Access Compliance Report Public Rights-of-Way (Curb Ramps)

Main Street: N/A Cross Street: YORBA_LINDA_BLVD Location: SW

ADA ID: RPAT220221112615 Ramp Type: Type 1 - Perpendicular Initial Pass/Fail: Pass Overall Compliance: No Severity Score: 22

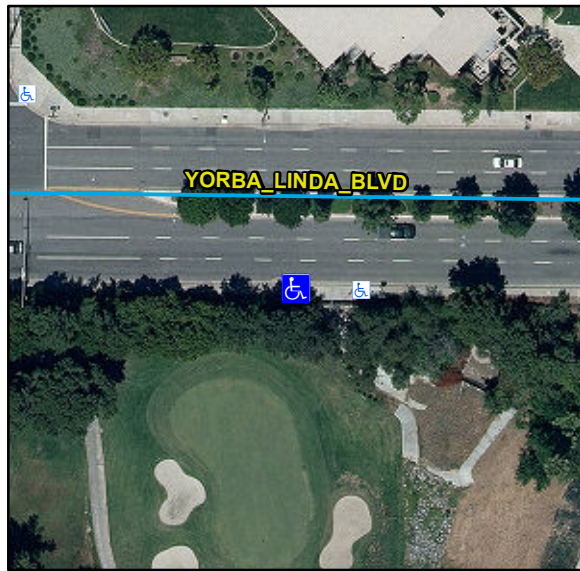
Remove & Replace Entire Ramp. Grind Gutter Lip.

R304.2.1, R304.2.2-Perp, R304.3.2-Para, R304.5.3, R305, R302.7, R302.7.2, STD 1115
